**WHEELING PLAN COMMISSION
THURSDAY, JANUARY 26, 2017 6:30 P.M.**

**AGENDA FOR A REGULAR MEETING OF THE PLAN COMMISSION
to be held in the Board Room of the Village Hall
2 Community Boulevard, Wheeling, Illinois**

REQUEST FOR PLAN COMMISSION ACTION
STAFF PROJECT REVIEW

RE: **Docket Nos. 2016-24A&B and PC 16-18**
(2016-24A) Zoning Variation to Reduce the Parking Setback
(2016-24B) Zoning Variation to Eliminate the Required Screening
(PC 16-18) Site Plan and Appearance Approval of a Parking Lot
300 S. Milwaukee Avenue
Site Plan and Approval for Construction of a Parking Lot

EXISTING CONDITION / DEMOLITION PLAN

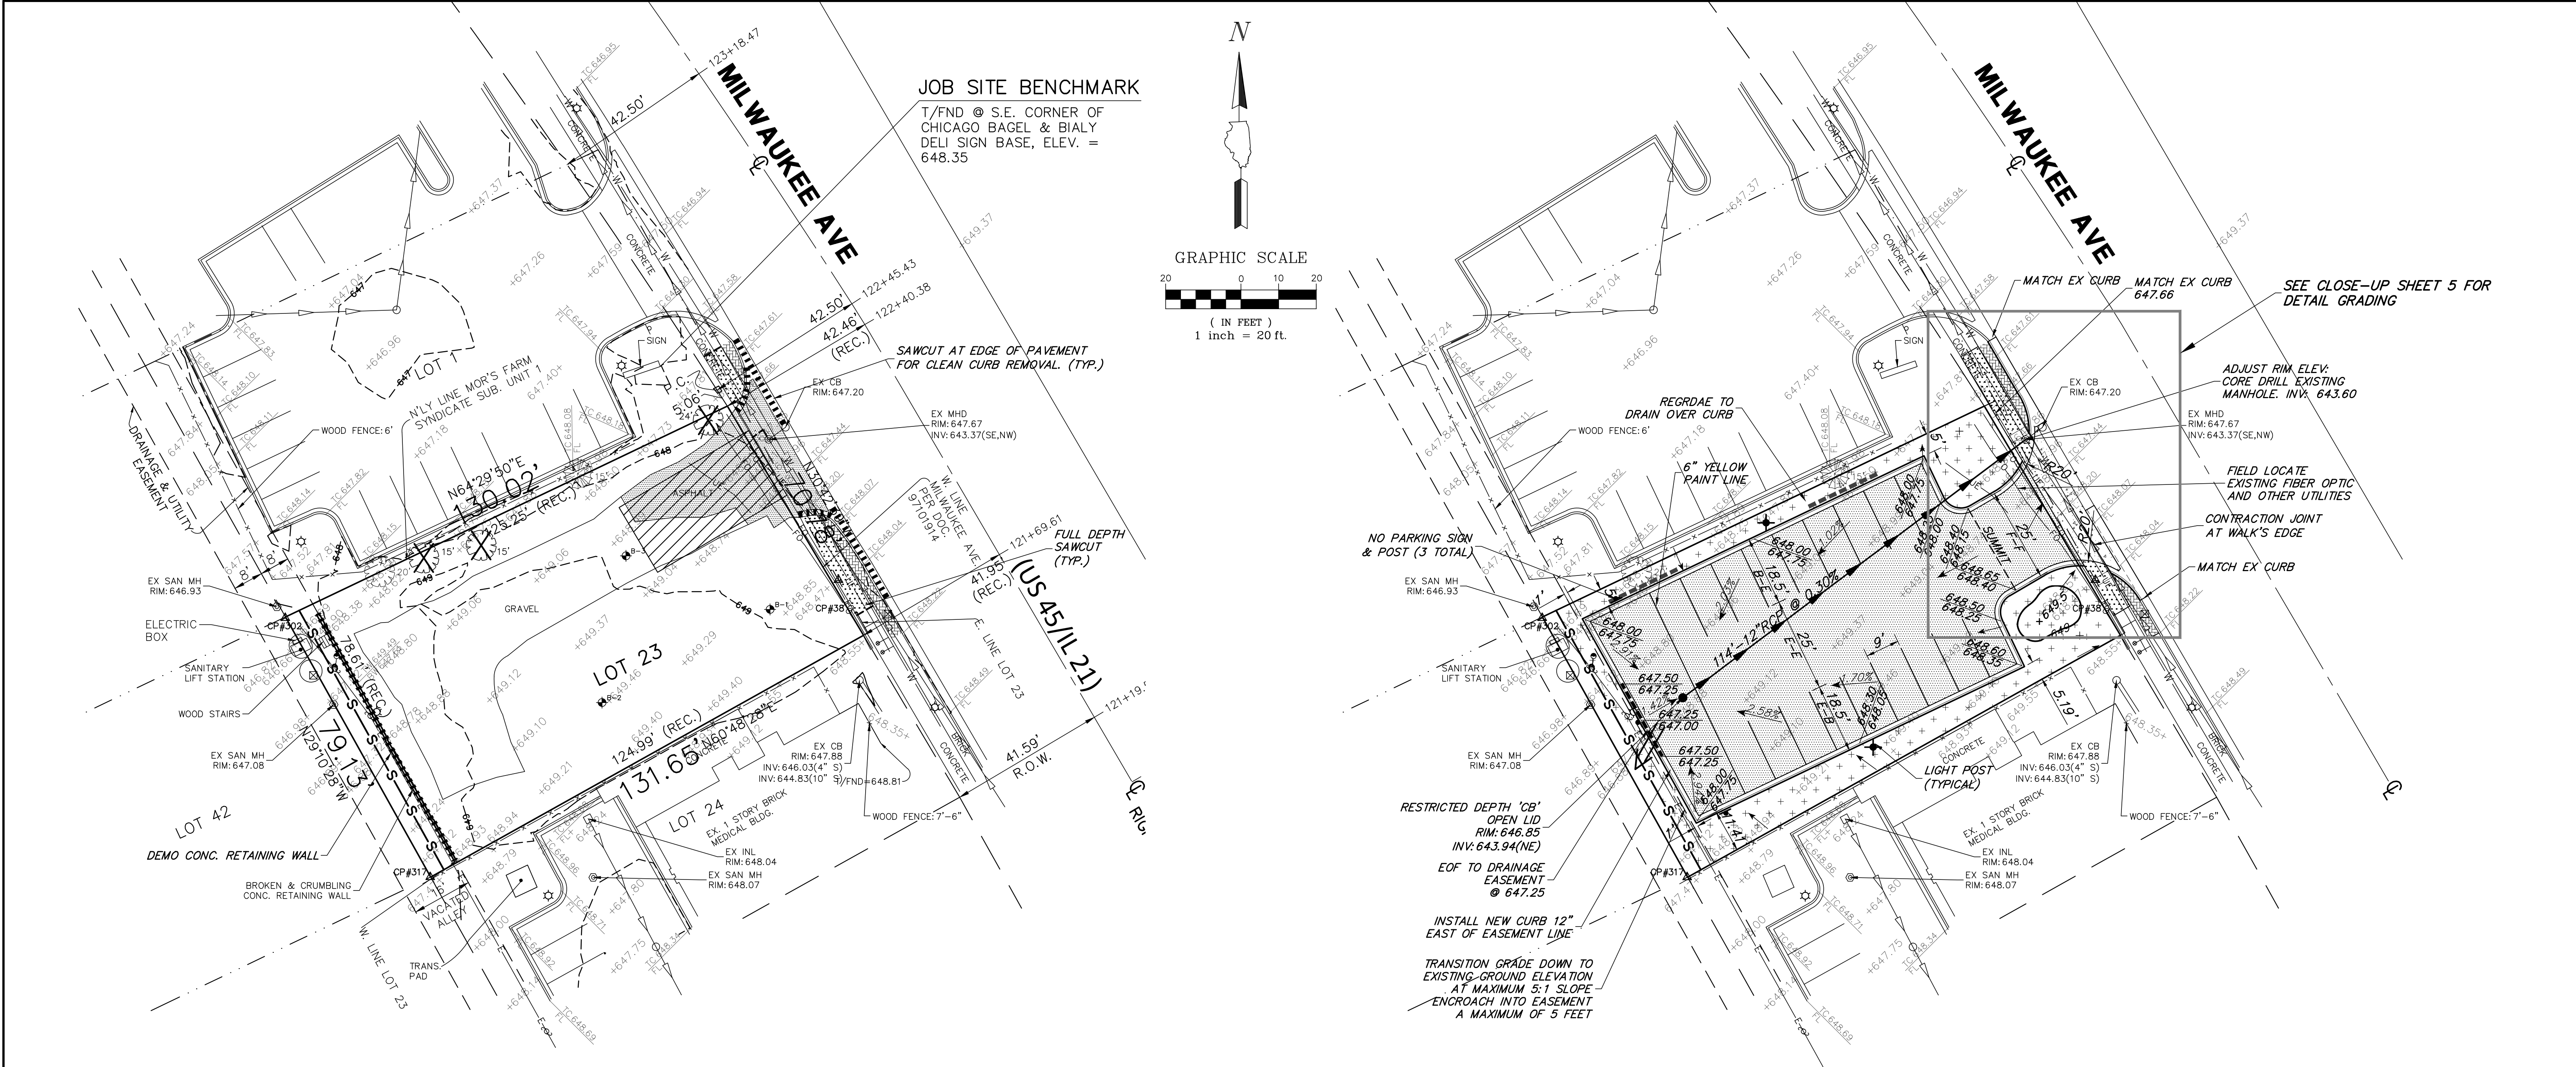
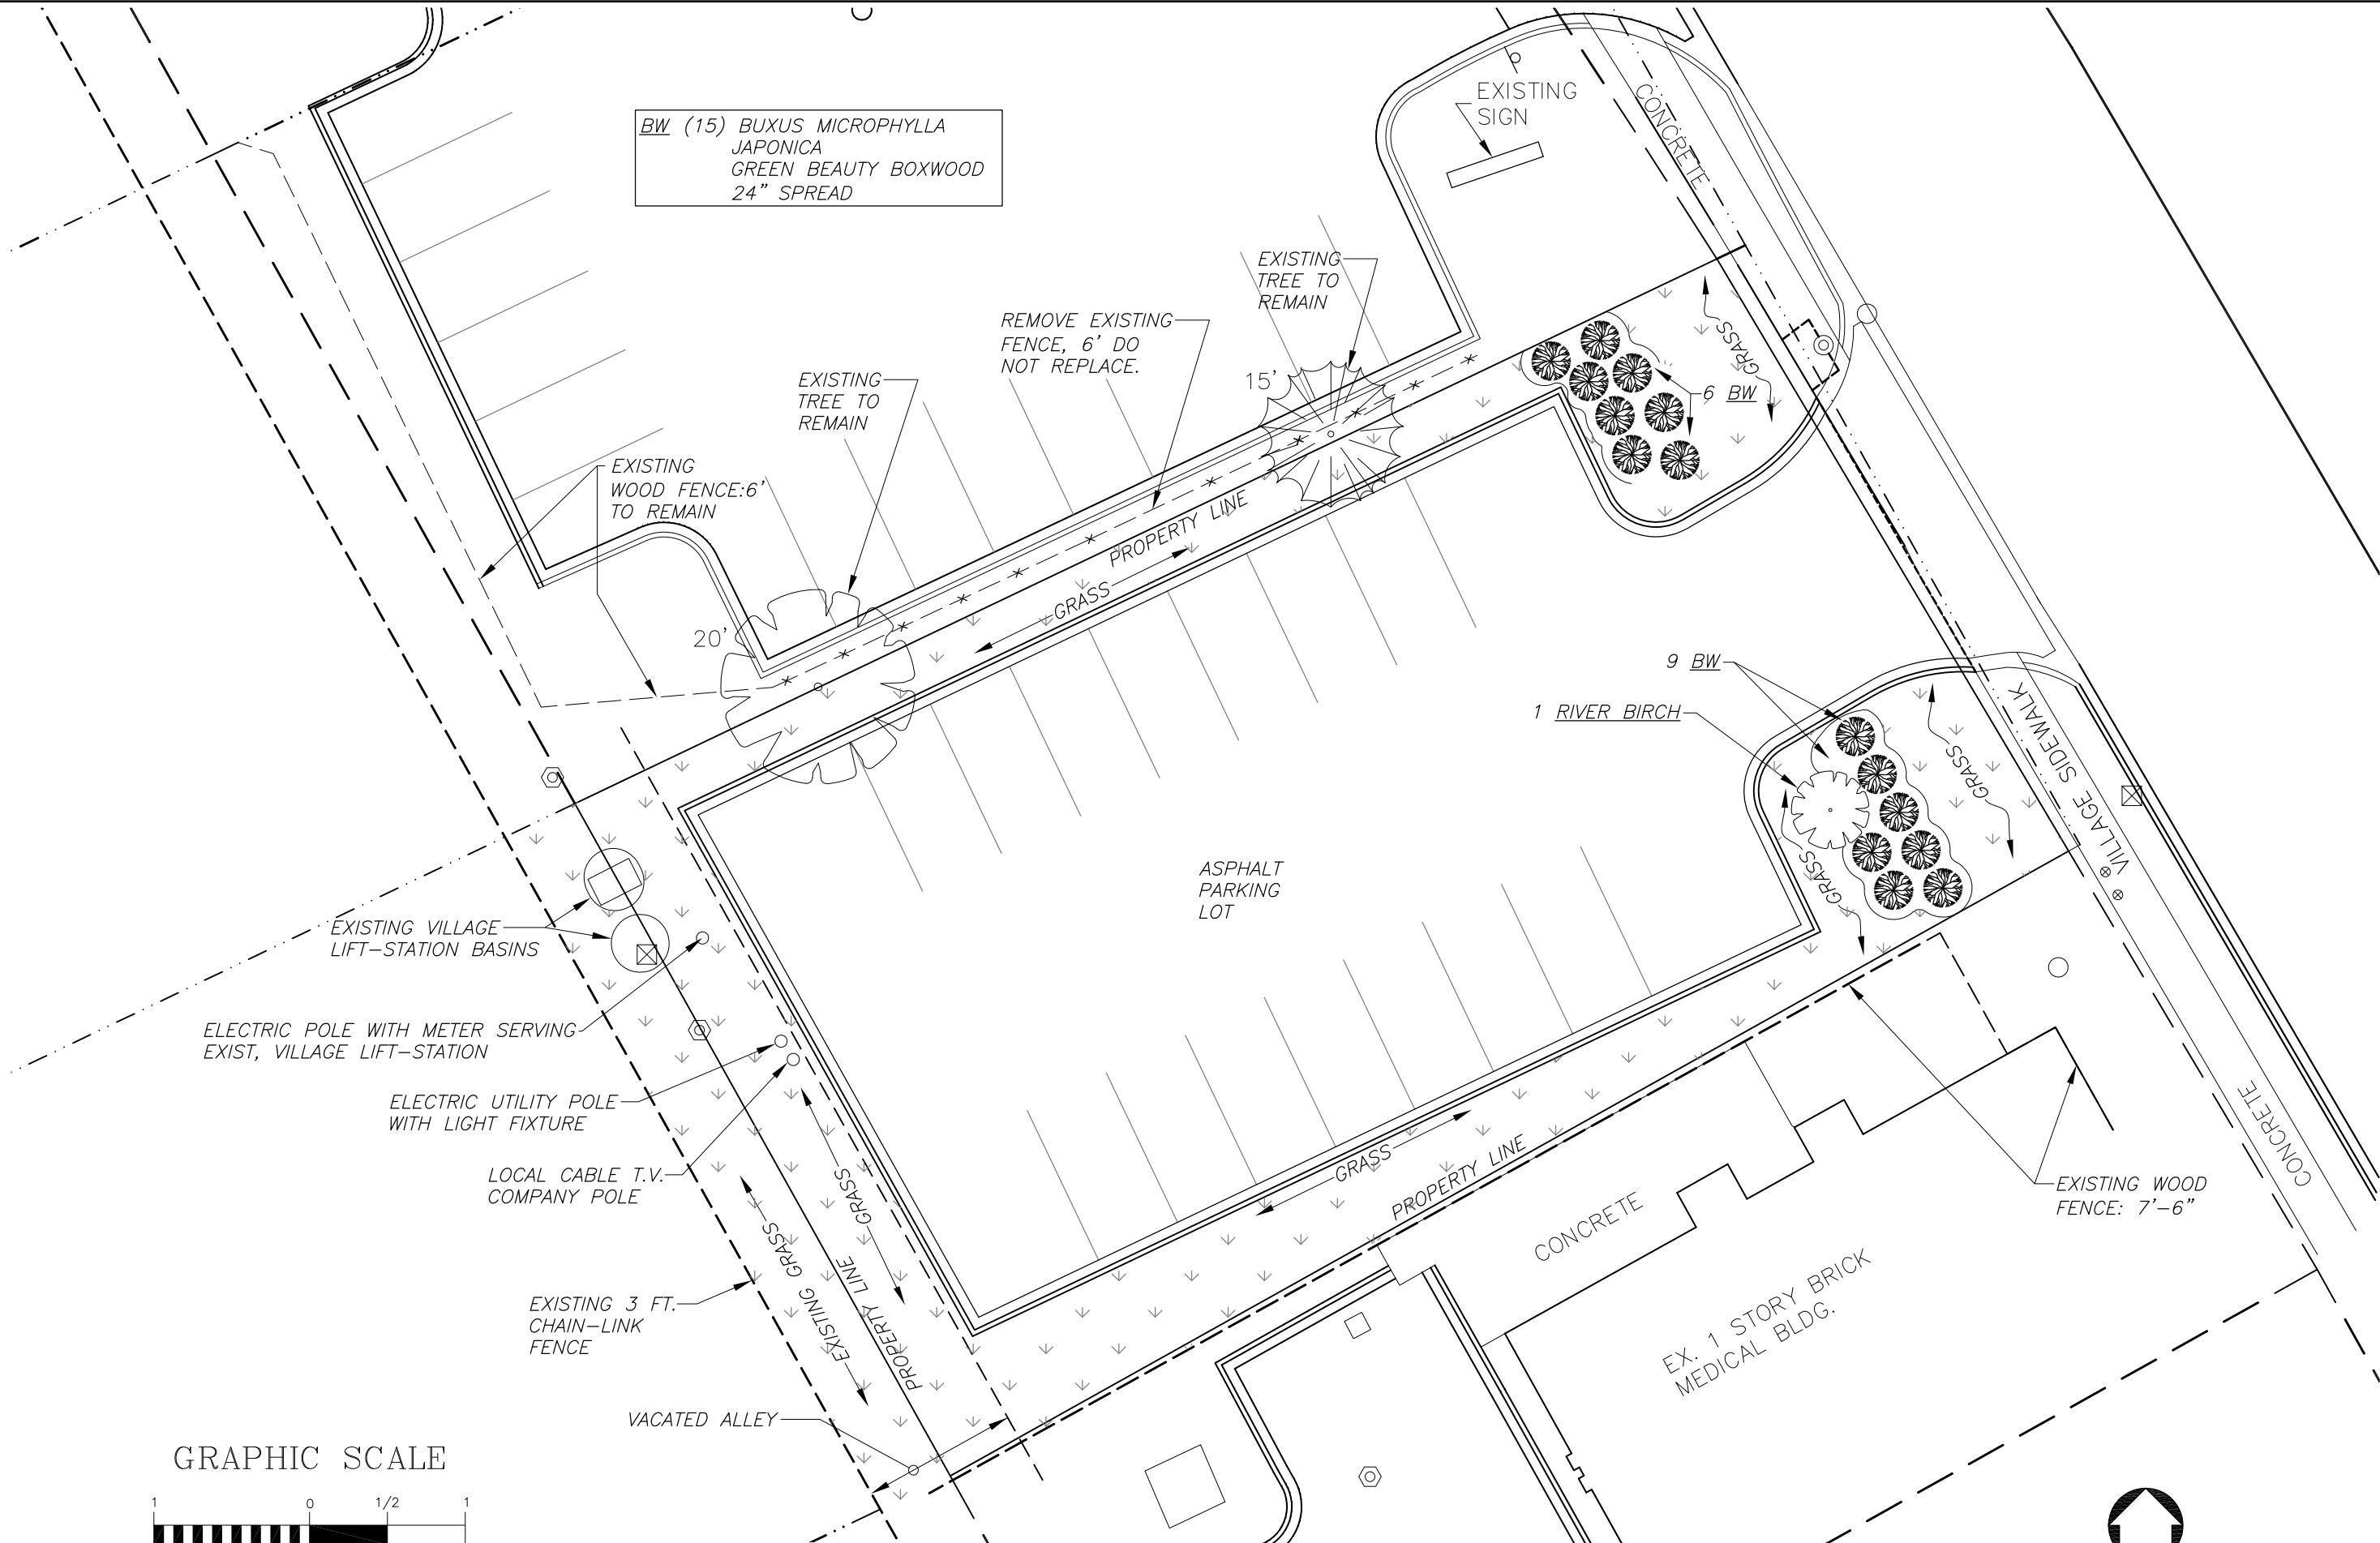
At this time, a screening plan acceptable to Public Works and the adjacent (rear) property owner has been reached. The Engineering Division has provided an exhibit that demonstrates an acceptable off-site location of a fence that will allow Public Works access to the utilities in the easement area. Since

Engineering Division Review: The Engineering Division has submitted comments and an exhibit dated 1.20.2017. In summary, continued Public Works access to the Village’s sanitary sewer lift station is critical. Screening (fencing or landscaping) cannot be located between the lot and the lift station. Public Works has been working with the adjacent (rear) property owner to devise a plan for the placement of a solid fence on off-site (see the attached exhibit) that would provide screening and allow for access to the lift station and other utilities. To ensure continued Village access to the lift station and other utilities at the rear of the subject property, an easement will need to be executed. A condition of approval regarding the easement has been added to the motion.

LIGHTING POLE INSTALLATION DETAIL

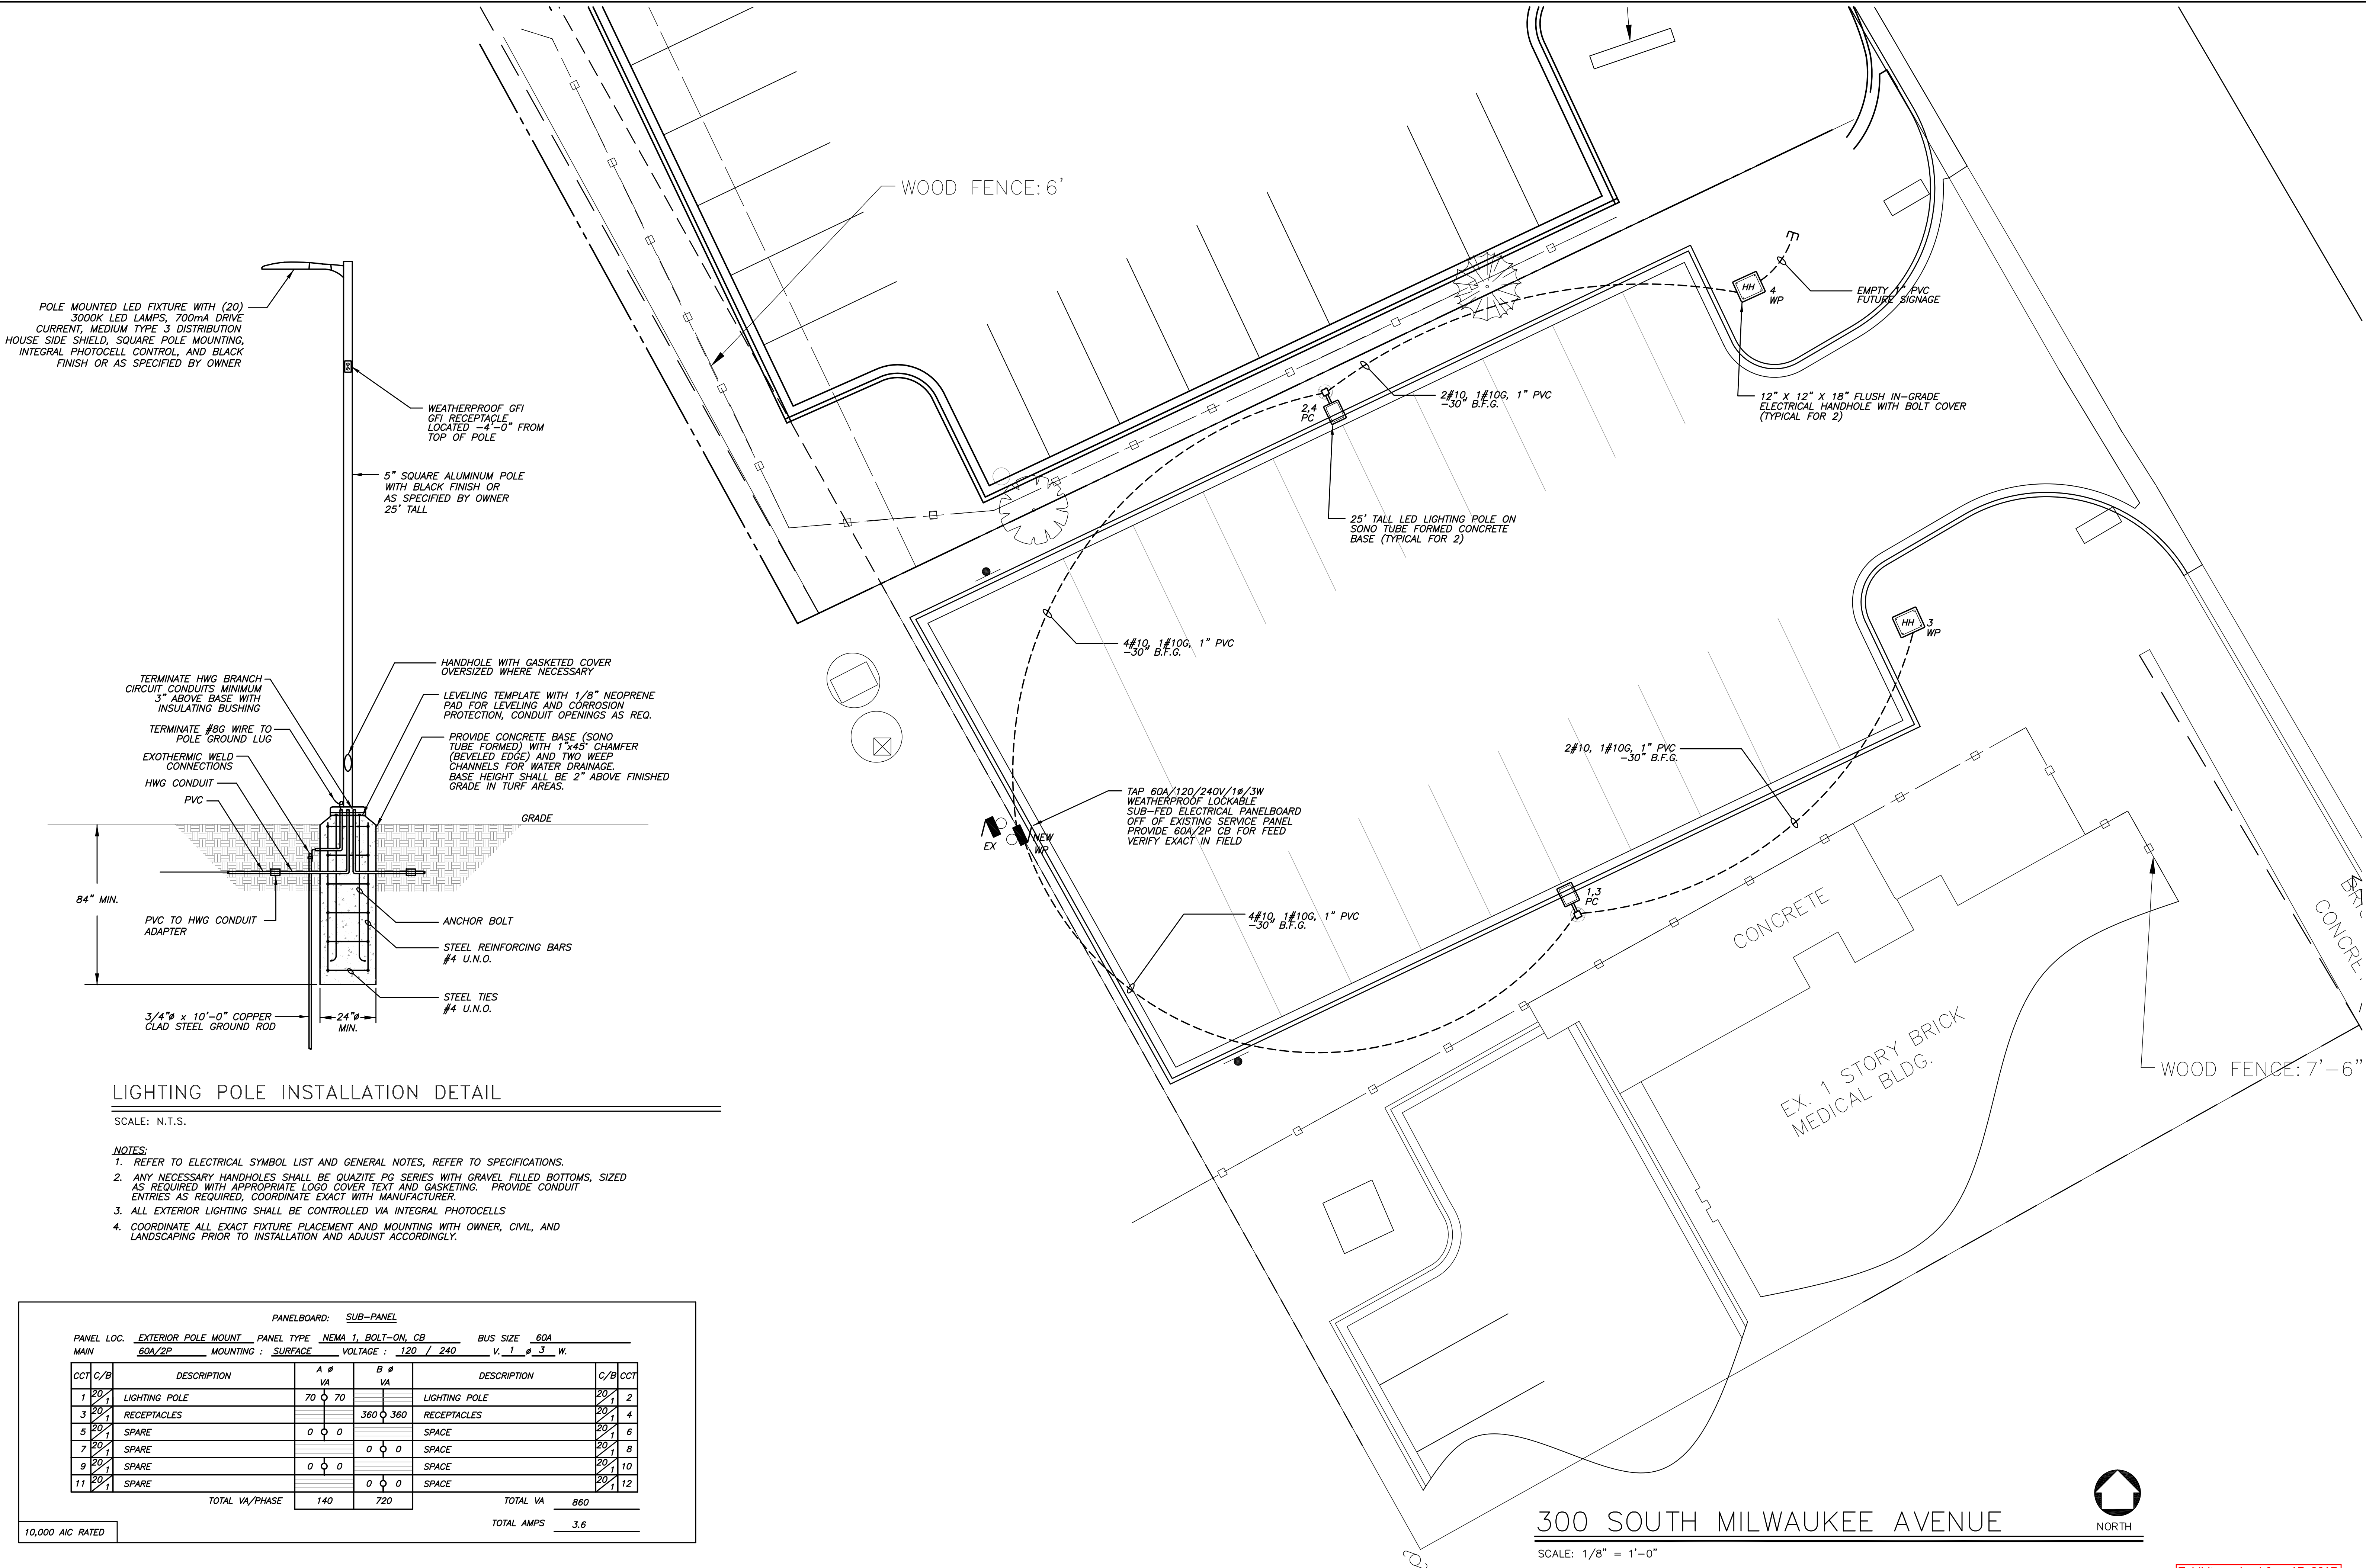
Lighting: A photometric plan and light pole plan have been provided. It appears that the lighting meets the requirements of the Zoning Code.
